LOUISIANA
POWER & LIGHT

January 27, 1983

SUBJECT: Waterford SES 3
Docket No. 50-382
Waste Management

As was discussed with your Mr. Jack Hayes on November 2, 1982, please find attached revised pages from FSAR Section 11.2 and a revised FSAR section 11.4. These changes reflect the latest design considerations in radioactive waste management at Waterford 3. The attached changes will be incorporated into the FSAR as part of the next amendment, but are forwarded to you now for your review.

Figure 11.4-1

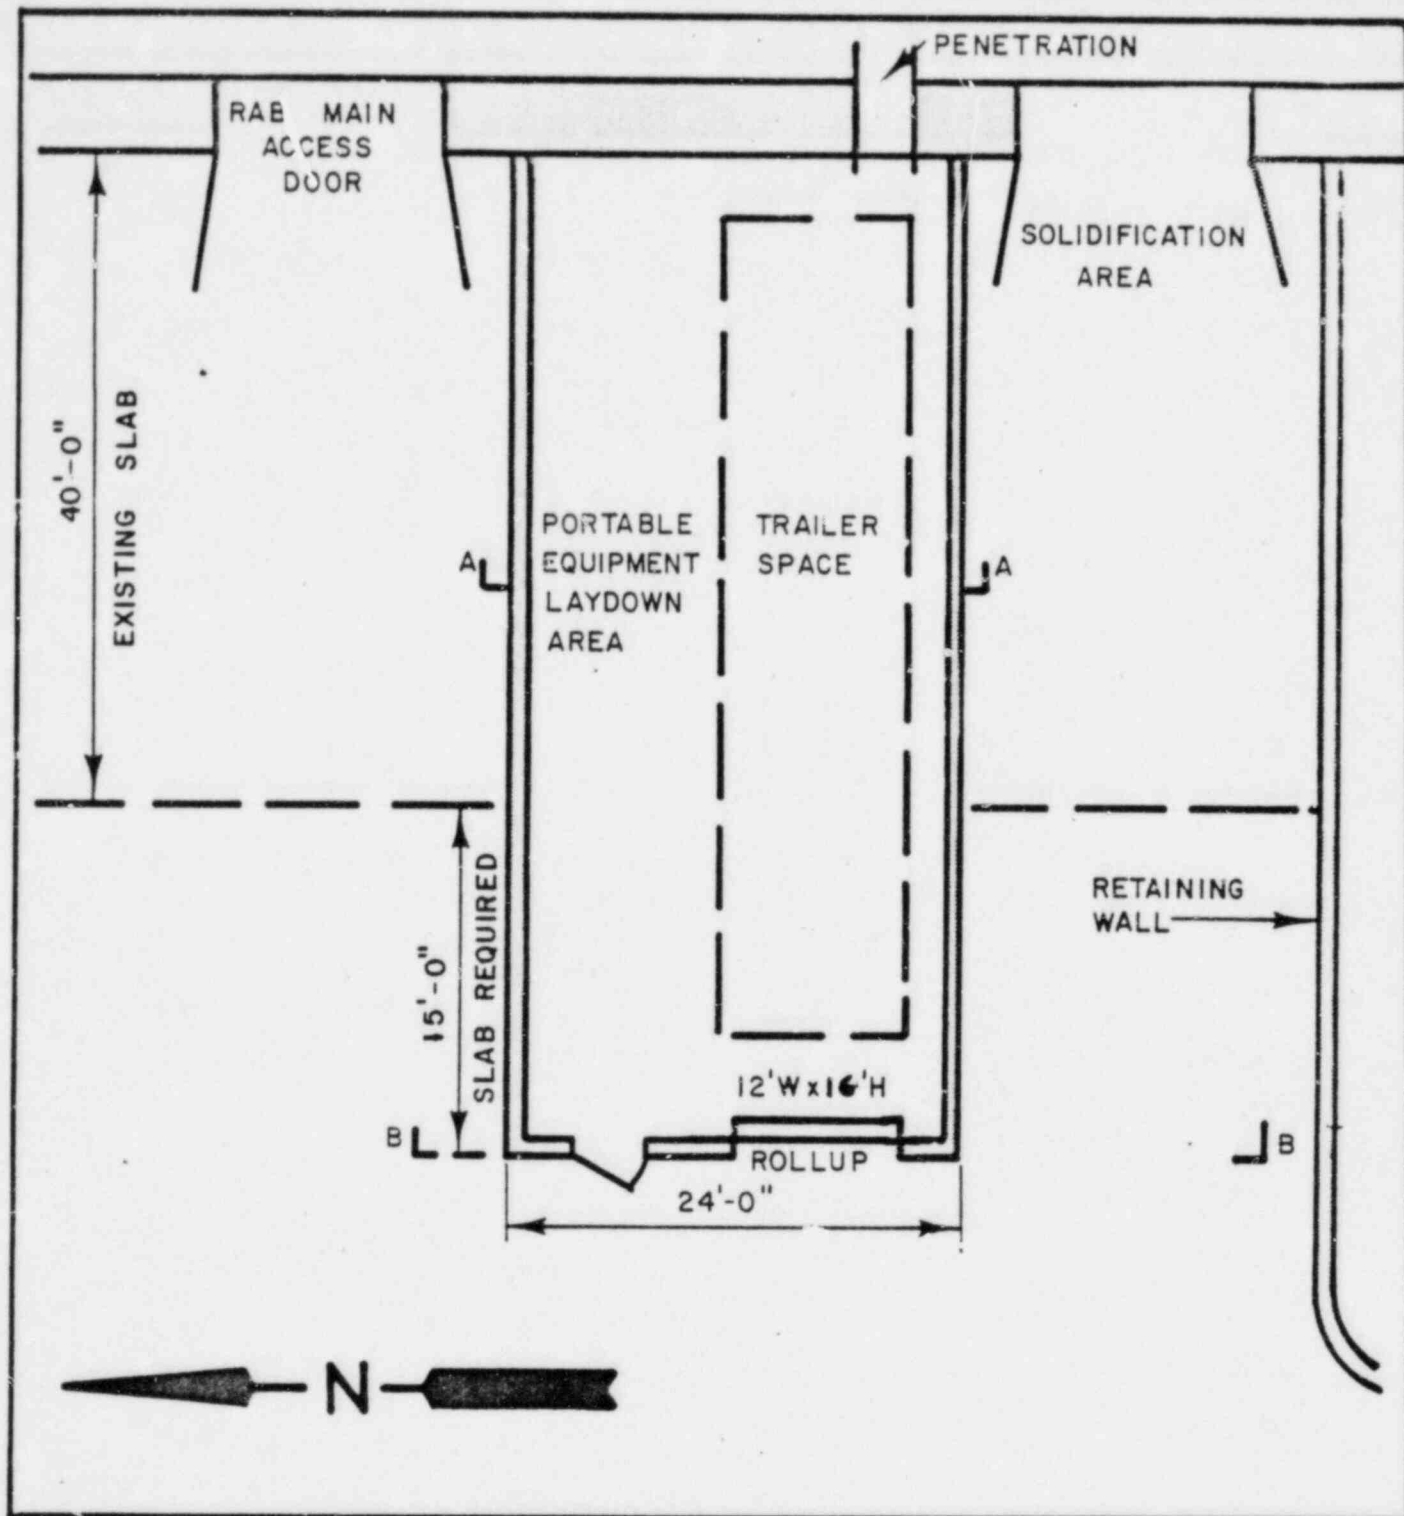
Waterford #3 will utilize a vendor supplied portable solidification system to provide for those plant solidification requirements not satisfied by installed plant equipment. This portable solidification system will be housed in a weatherproof structure with curbing and a sump system which discharges to the LWMS. An overhead bridge crane is provided for lifting requirements up to 10 tons. This structure will be located on the west side of the RAB adjacent to the existing in-plant solidification area (See Figure 11.4-1).

The PSF is a pre-engineered, prefabricated sheet metal building with interior dimensions of 24' wide by 55' long with a 30' high eave. The building is located on the concrete truck platform on the west side of the RAB. The area selected for erection of the PSF is between the RAB main access doors and the solidification area doors at elevation +21'. (See Figure 11.4-1)

Figure 11.4-2

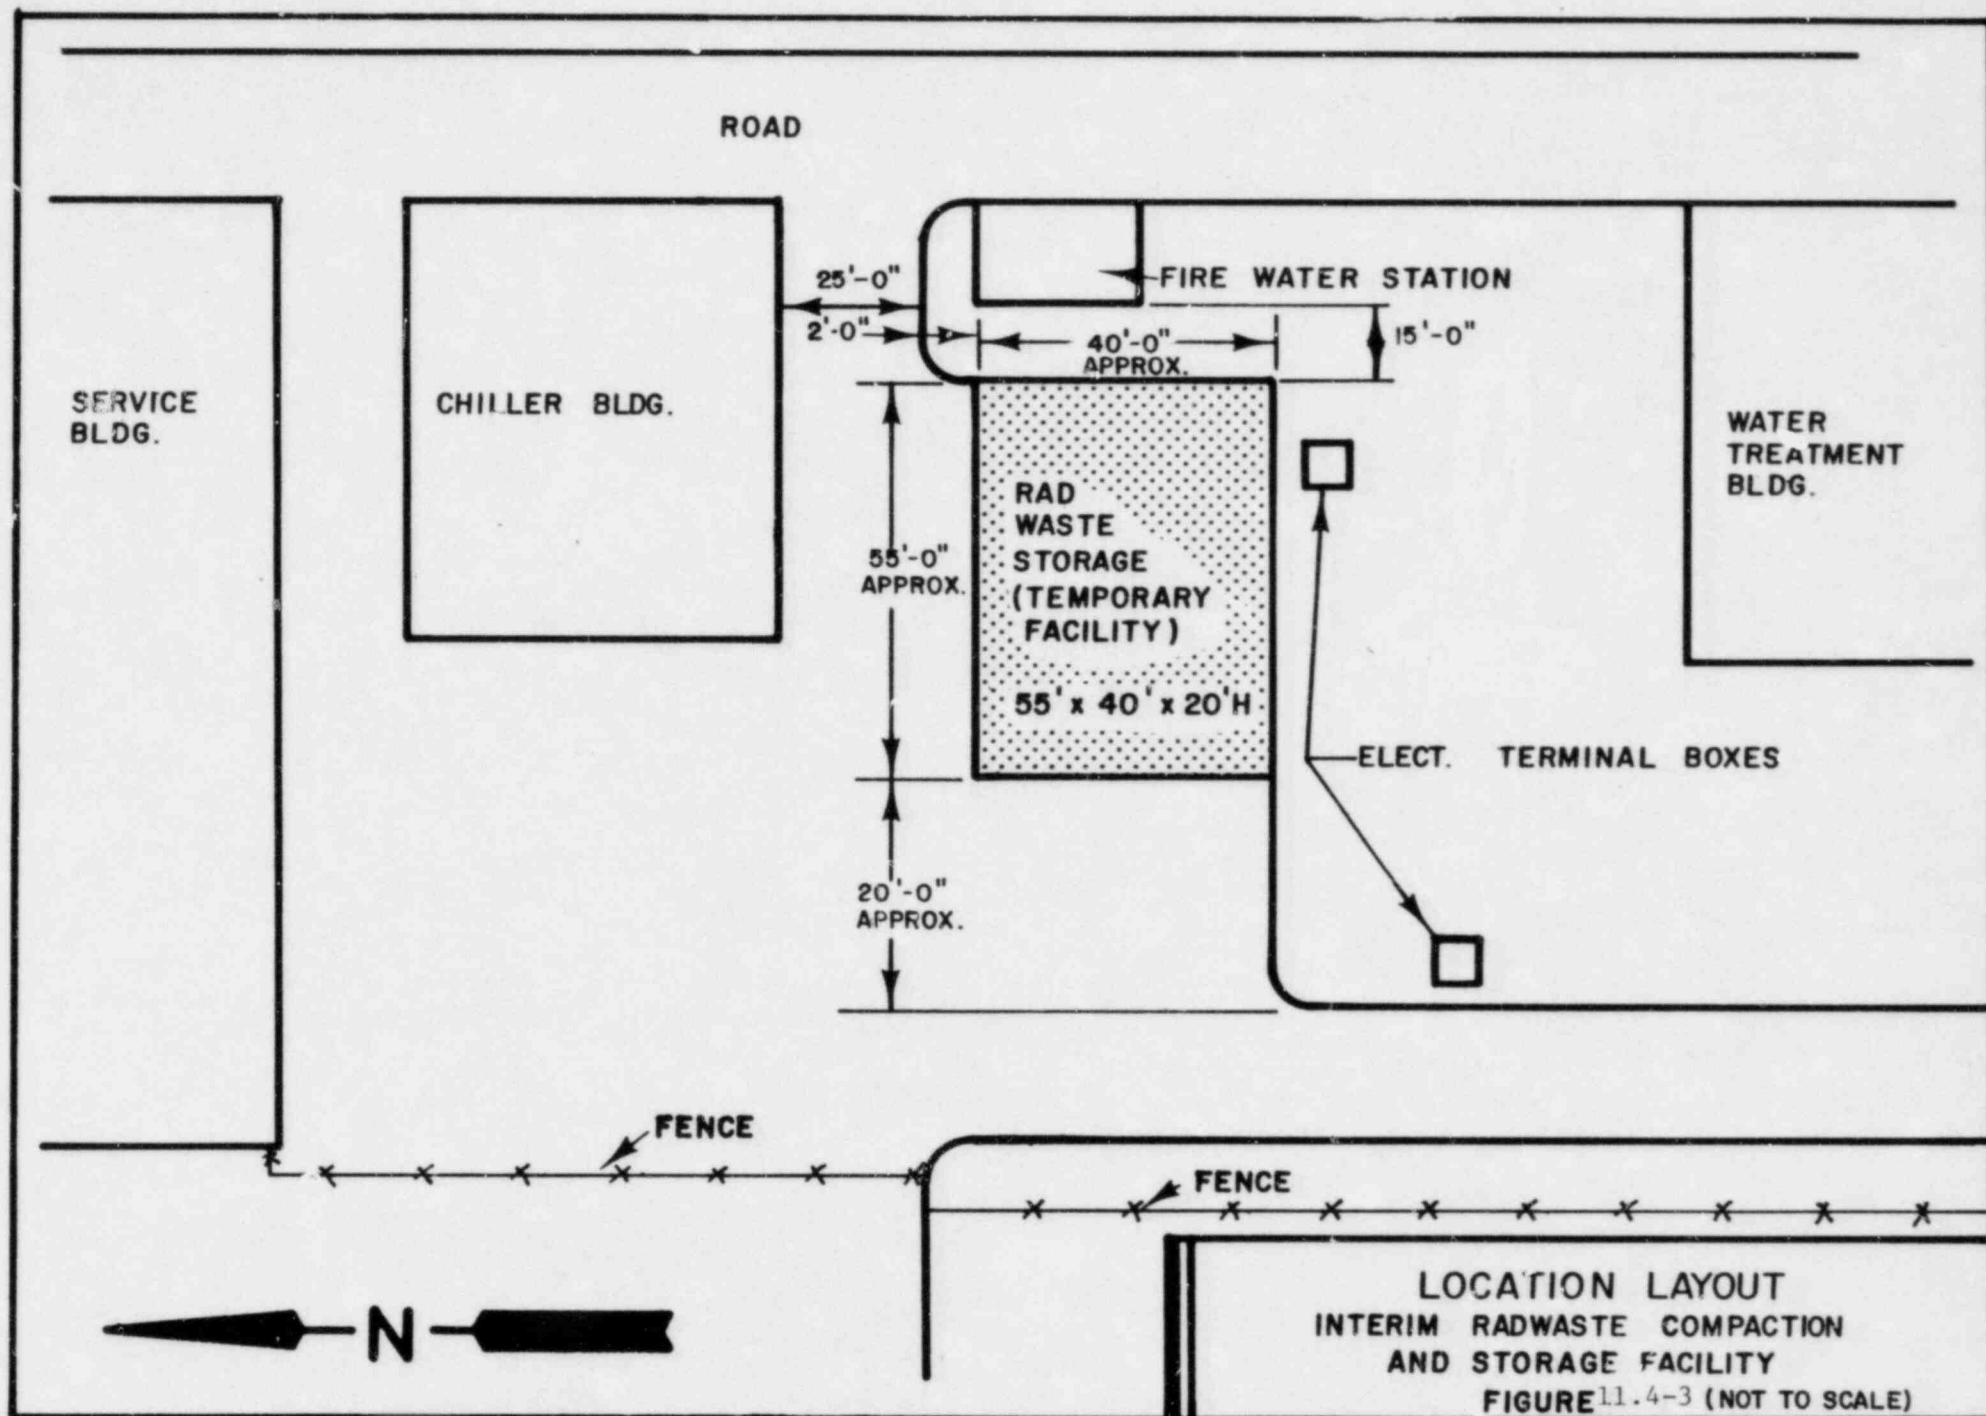
The operation of waste solidification (and/or resin dewatering) will be performed in a shielded waste liner mounted upon a trailer. This trailer shall be backed into the PSF and the work performed in this enclosed building. Waste is supplied to the liner by flexible hoses connected to waste transfer lines routed from inside the RAB out to the PSF. Support equipment for the portable system is mounted on skids. The PSF will supply space for the trailer, the skid mounted equipment, and materials required by the contractor for solidification. (See Figure 11.4-2)

Figure 11.4-4

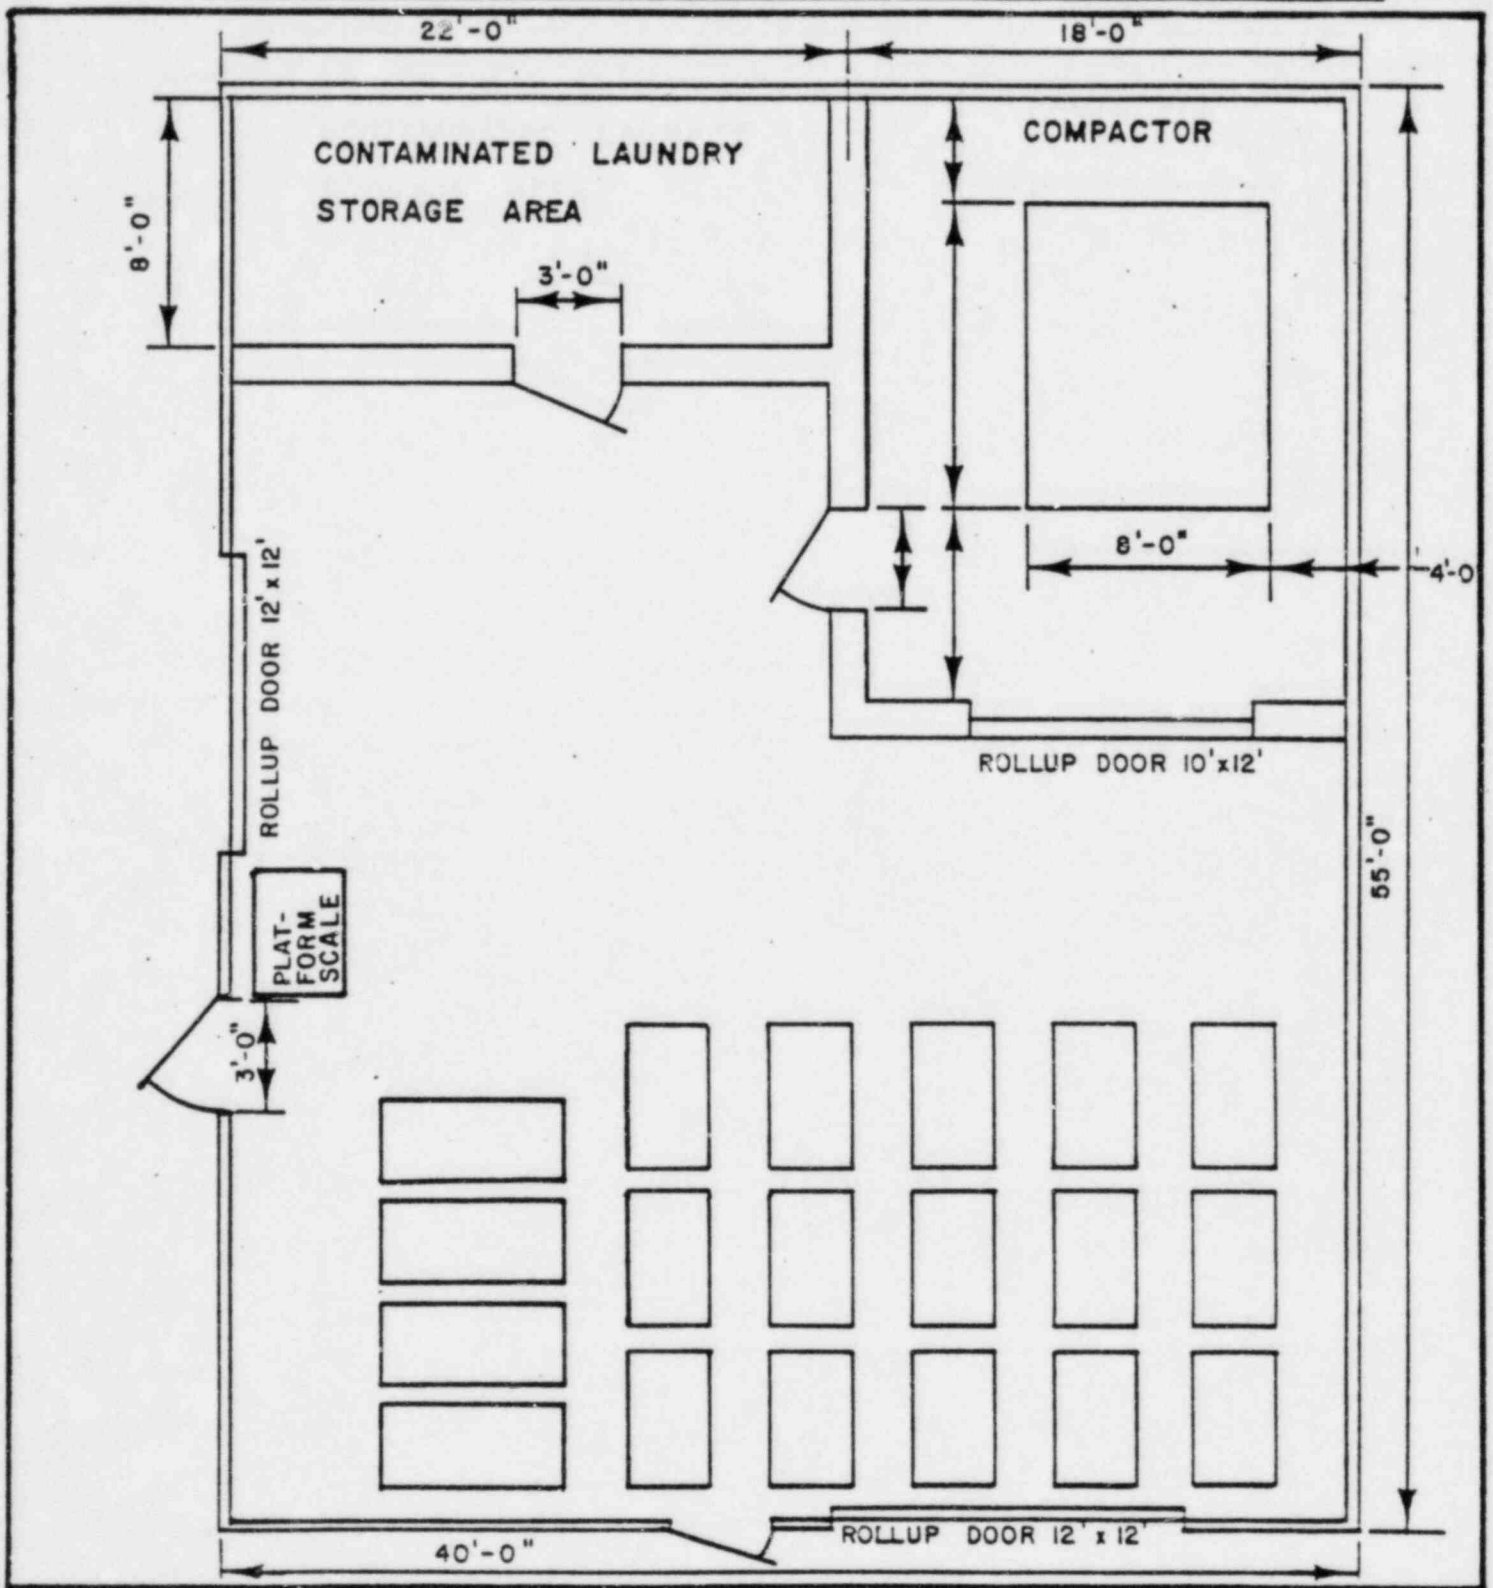
The building is 55' by 40' and has sufficient storage capacity to house 76 compacted 6' X 4' X 4' metal waste boxes. The boxes are handled with a forklift. (See Figure 11.4-4).
